MIL-PRF-83536/8
AMENDMENT 2
10 July 1999
SUPERSEDING
AMENDMENT 1
15 December 1995

PERFORMANCE SPECIFICATION SHEET

RELAYS, ELECTROMAGNETIC, ESTABLISHED RELIABILITY, 4PDT,
LOW LEVEL TO 5 AMPERES, PERMANENT MAGNET DRIVE, MAGNETIC LATCH,
HERMETICALLY SEALED, ALL WELDED, TRANSIENT SUPPRESSED DC COILS

CIRCUIT DIAGRAM
(OPTIONAL INTERNAL
DIODE CONFIGURATION)

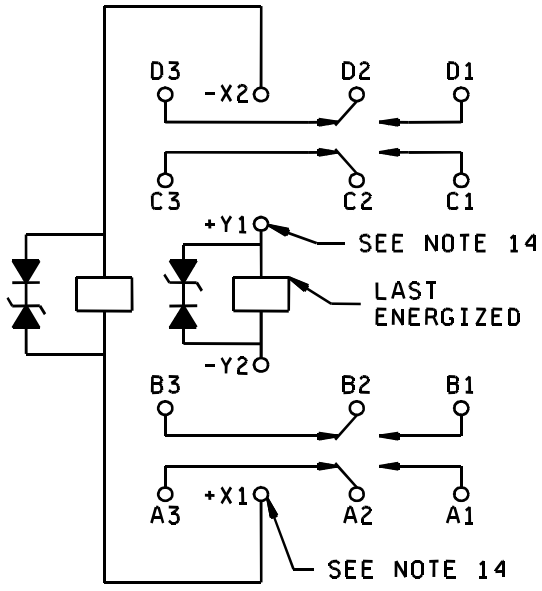
FIGURE 1, add the following circuit diagram:
